ADDENDUM NO. 1

RE: Item #3, February 17, 2016 Letting - IM 0901(162)14, P 014A(11)8, PCN 020U, 0217, Lawrence County - Reconstruct Interchange, Reconfigure Ramps, & Reconfigure Service Road

PLANS: Please destroy sheets A2, A3, A5, B2, B5, B6, B7, B9, B10, B43, B62, B63, B71, B72, C2, C5, C8, D7, E71, F2, F7, and L2 and replace with the enclosed sheets, dated 1/28/16, 1/29/16, 2/1/16, 2/2/16, 2/3/16. Sheet B15A was added.

STATE OF SOUTH DAKOTA	PROJECT	SHEET	TOTAL SHEETS
	IM 0901(162)14 P 014A(11)8	B6	B192

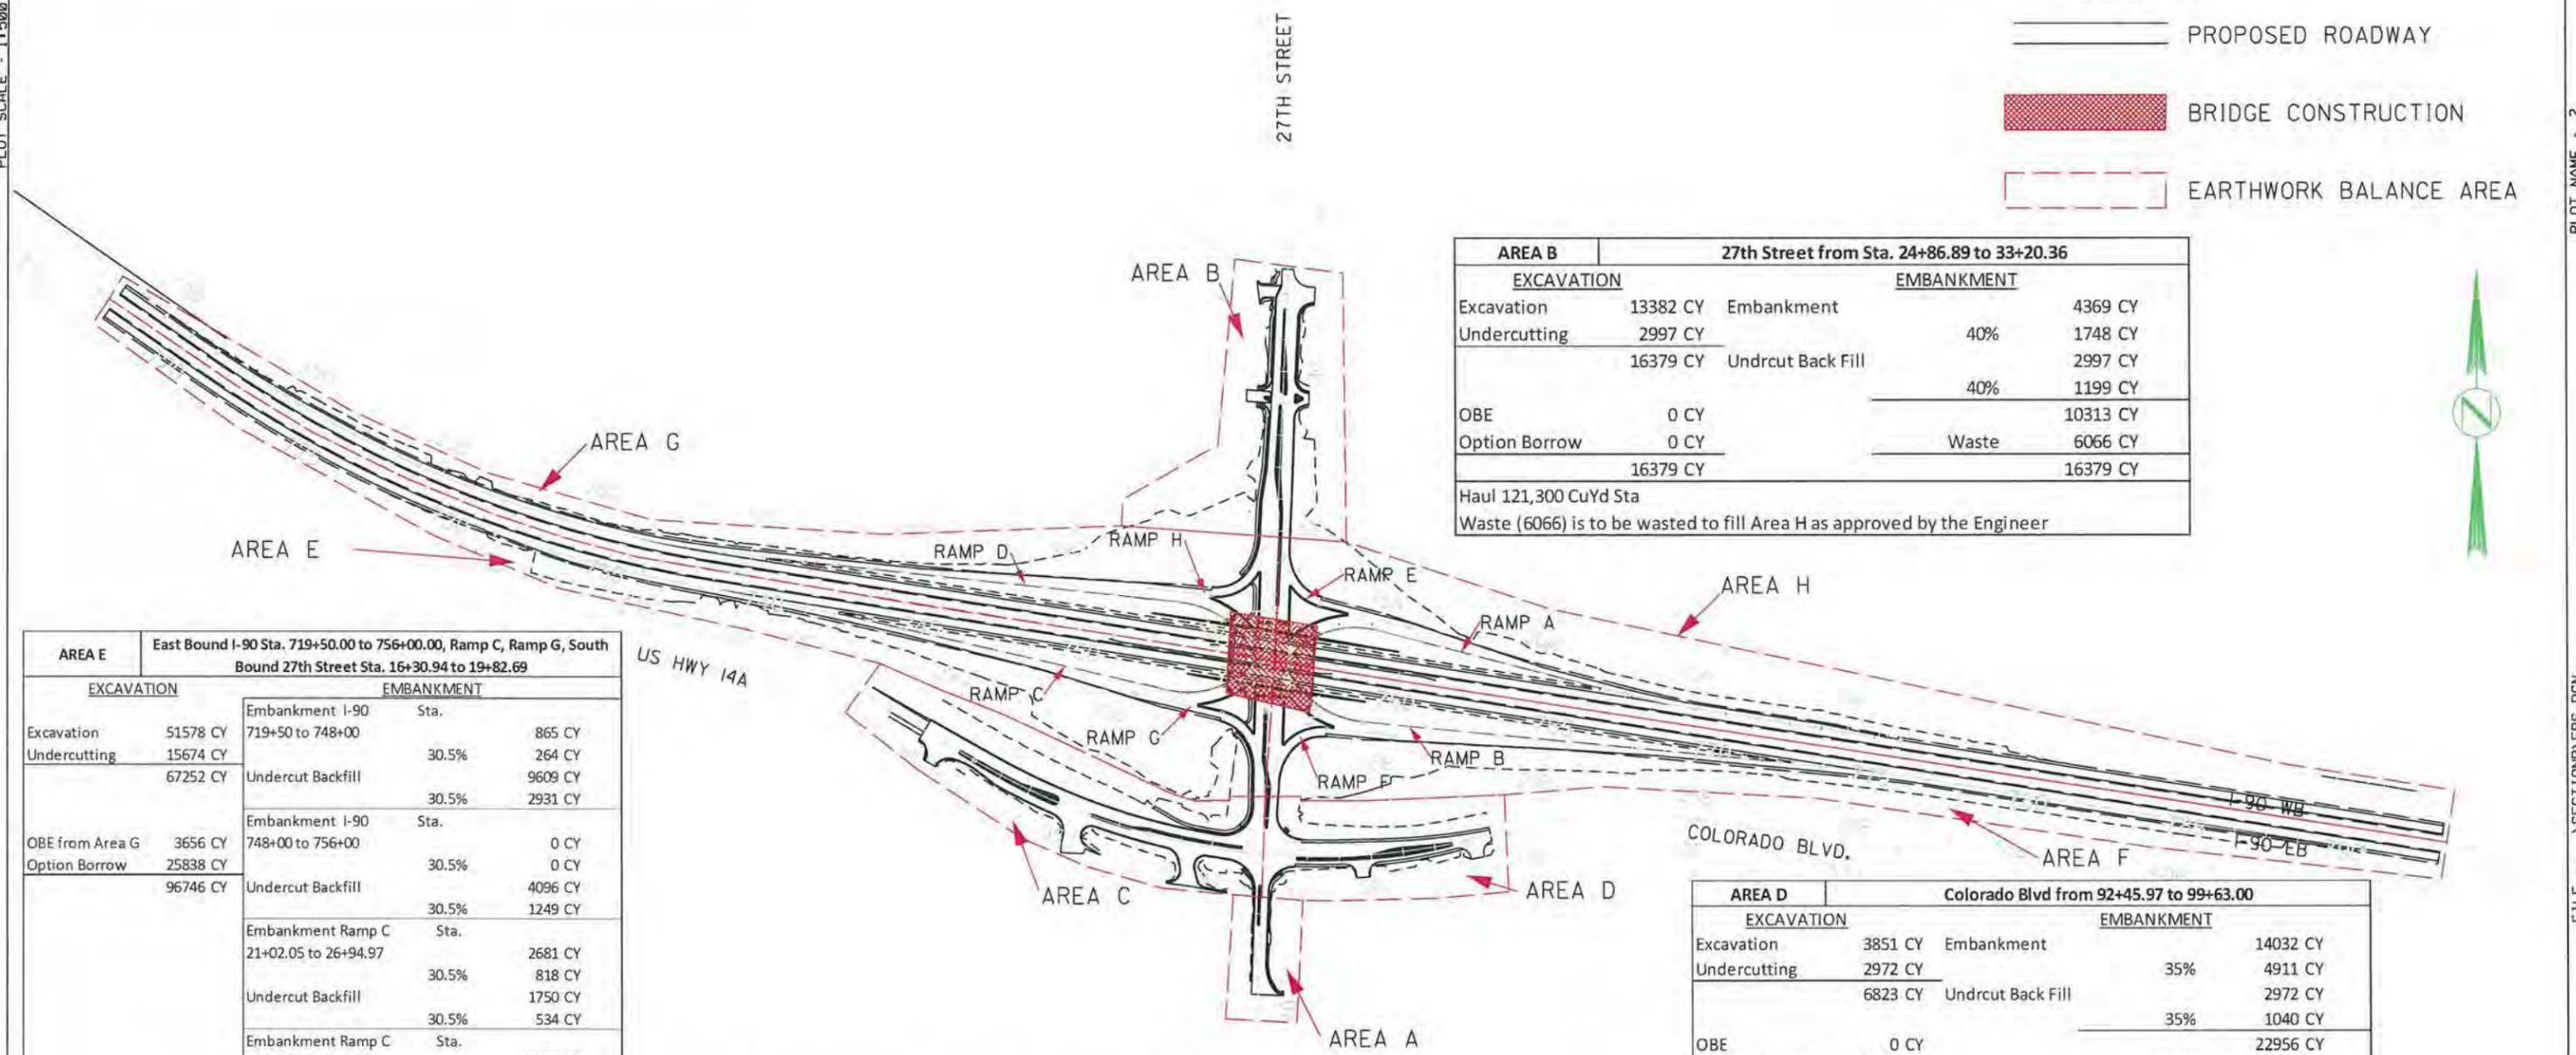
- Sheets B5, B6 & B10:** Stationing for Undercutting was updated.
- Sheet B7 & B9:** Stationing for Undercutting in Section F was added.
- Sheet B15A:** Sheet was added for Berm Notes and Quantities for Base Course and Geogrid Reinforcement.

STATE OF SOUTH DAKOTA	PROJECT	SHEET	TOTAL SHEETS
	IM 0901(162)14 P 014A(11)8

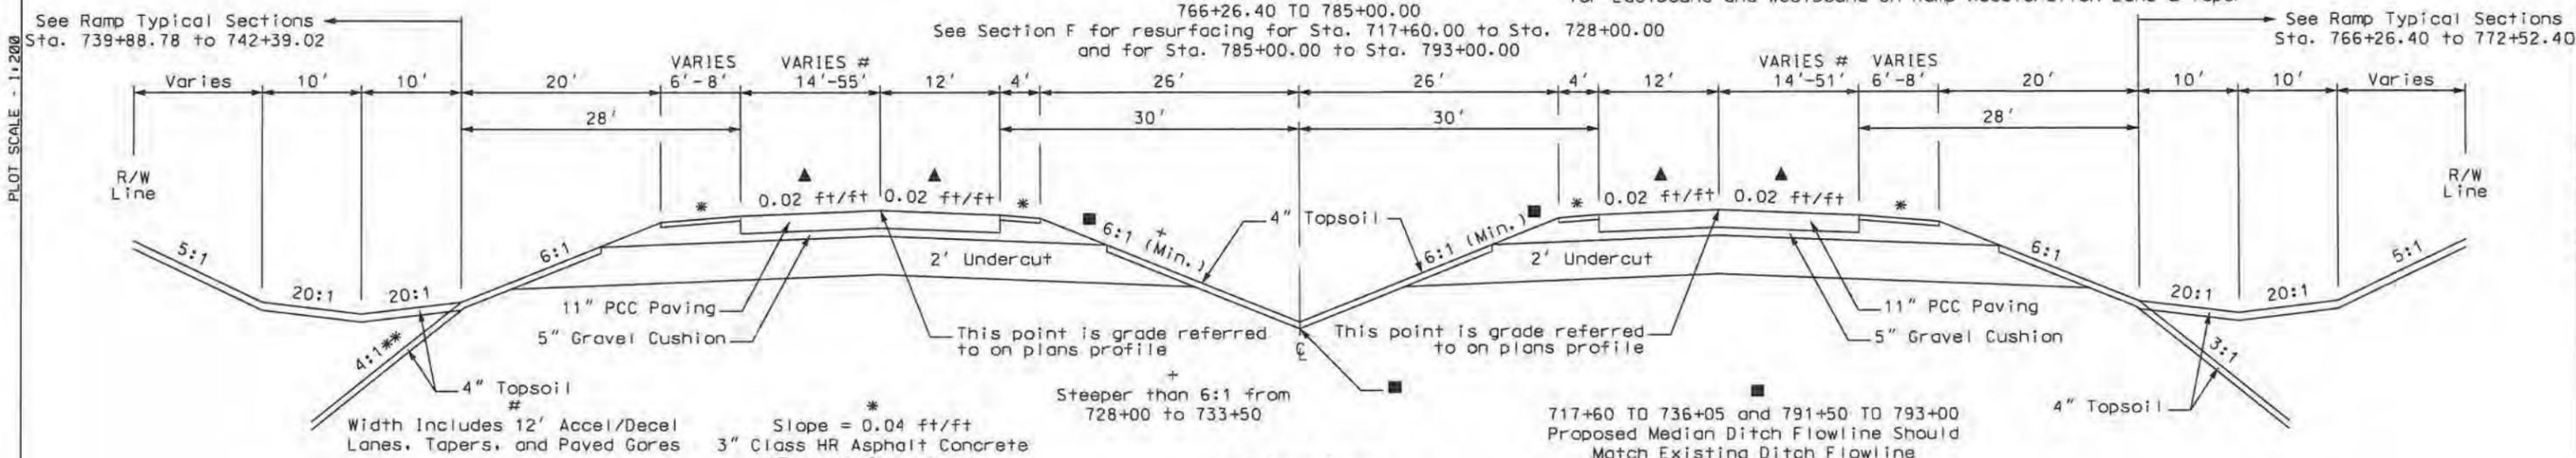
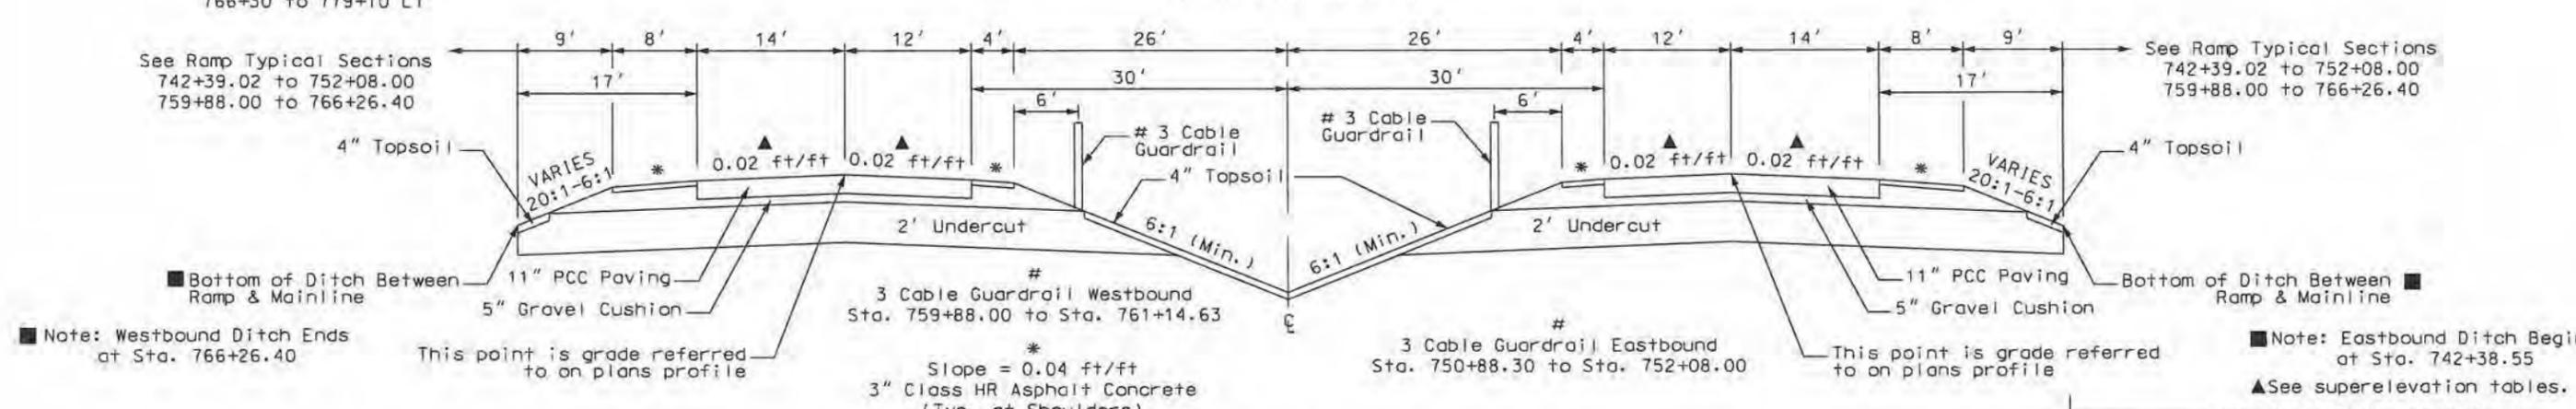
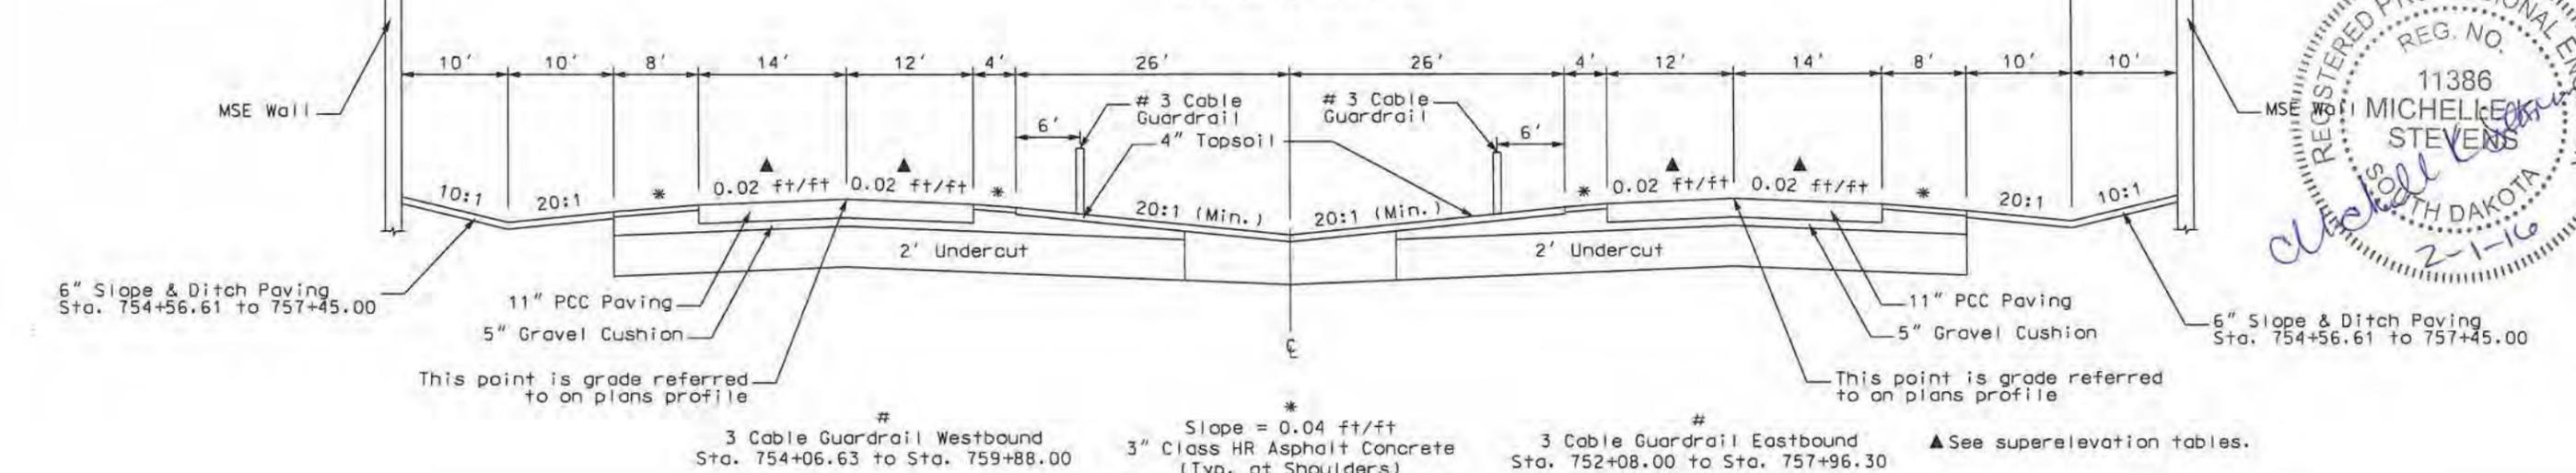
- Sheet B43:** Typical Section for Stationing for Undercutting was updated.
- Sheets B62, B63, B71 & B72:** Profile for Stationing for Undercutting was updated.
